## **Disconnect Cutout Modification D1 to D2**

## **Modifications**

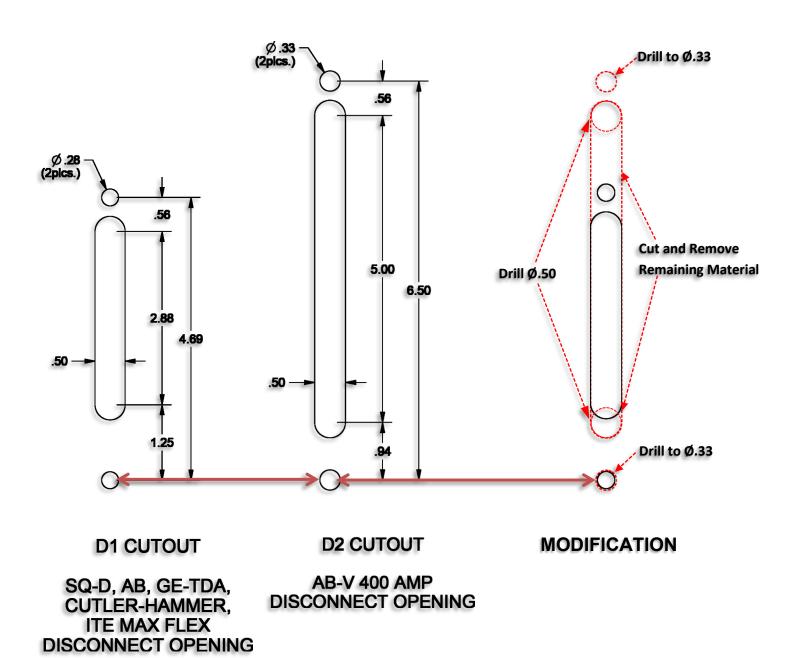
To modify a D1 cutout to a D2, concentrically align bottom Ø.28 cutout on the D1 cutout to the location of the bottom hole of the D2 cutout. Defeater studs are correctly located using this bottom hole.
